REMARKS

Applicant has studied the Office Action dated June 1, 2004. Claims 1-9 and 20-25 are pending. Claims 10-19 have been canceled without prejudice in response to a previous restriction requirement. Reconsideration and allowance of the pending claims in view of the above amendments and the following remarks are respectfully requested. Reconsideration and allowance of the pending claims in view of the above amendments and the following remarks are respectfully requested. In the Office Action, the Examiner:

FIG. 6

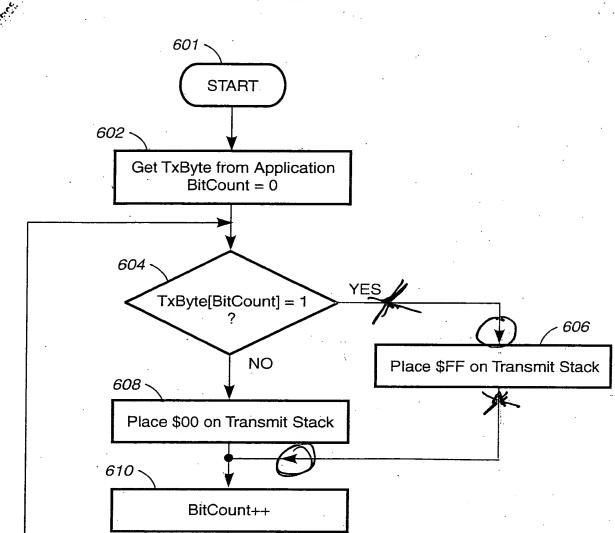
Further, FIG. 6 has been amended to properly illustrate the arrows from decision block 604 to block 606 to correctly denote the flow. Similarly FIG. 7 has been amended to properly illustrate the arrow

ANNOTATED SHEETS SHOWING CHANGES
